C/ 030 SC 30.5.1.1 Lewis, Jon	I.4 P 30 Dell	<i>L</i> 1	# [1	C/ 110B SC 110B Hajduczenia, Marek	P <b>225</b> Bright House	L 8 Network	# 4
Comment Type E If the MAU is a 10M b	Comment Status X	or consistency		Comment Type E Missing serial "," in "25	Comment Status X 5GBASE-CR, 25GBASE-CR-	S and 25GAUI	C2M"
SuggestedRemedy Change 10M b/s to 10 Proposed Response	0 Mb/s. Response Status <b>O</b>			Same fix on page 228 line 14, in 110B.2.4 (ca	-CR, 25GBASE-CR-S, and 2 , line 9, in 110B.2.1; and page aption)		n 110B.2.2.2; page 229,
	P 54	L 19	# 2	Proposed Response	Response Status O		
would indicate Manda to be reversed in the SuggestedRemedy I think for the column	Dell Comment Status X e line for 25GBASE-KR: I don't atory/Optional which doesn't ma table and table footer. labeled RS it should only be "I stent by changing the table foot Response Status O	ake sense. Also	, O(a) and (a)O seem should be removed.	Cl 110C SC 110C.1 Hajduczenia, Marek Comment Type E Missing serial comma SuggestedRemedy Change to "CA-L, CA- Proposed Response Cl 110C SC 110C.1 Hajduczenia, Marek	P 230 Bright House Comment Status X in "CA-L, CA-S and CA-N" S, and CA-N" Response Status O P 230 Bright House	L 48	# <u

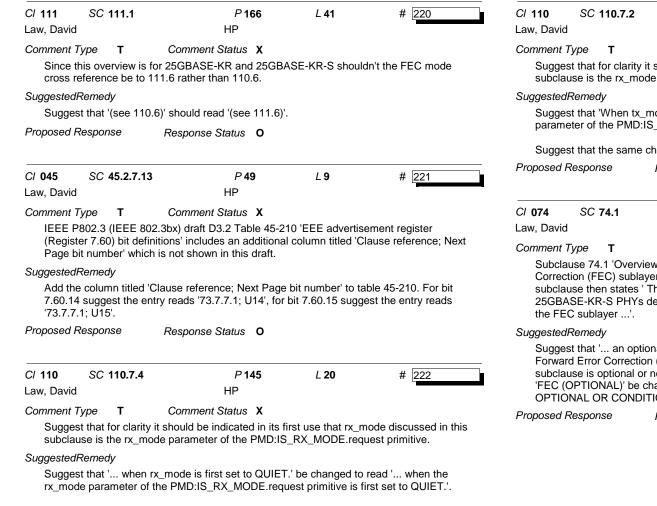
Suggest '... for 10GBASE-R ...' be change to read '... for 10GBASE-R and 25GBASE-R ...'.

Suggest that the same change be made to subclause 111.7.4 (page 171, line 12).
